Reference: 2023-003M

## URGENT - FIELD SAFETY NOTICE

### AIR/WATER VALVE MAJ-1444 (Lot No: All lot numbers)

## Addendum – Instructions for use

Sample images as an example of the damaged MAJ-1444 are below.

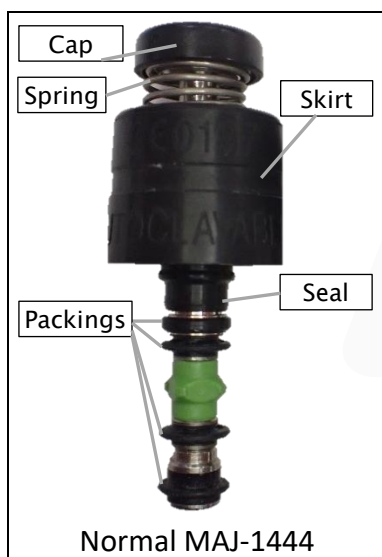
#1 Sample images of the damaged MAJ-1444 are added in Chapter 3, “3.2 Inspection of the valve”.

While referring to Chapter 2, “Instrument Nomenclature”, visually inspect the valve and all of its components visually as follows:

- Confirm the hole is not blocked.
- Confirm that the valve is not deformed or cracked.
- Check for excessive scratching or tears in the seal and packings.
- Confirm that the seal or packing is not peeled off.

The following sample images are only an example and the MAJ-1444 should not be used if any abnormality is suspected, please use new one.

- Never use the valve on a patient procedure if an abnormality is suspected.
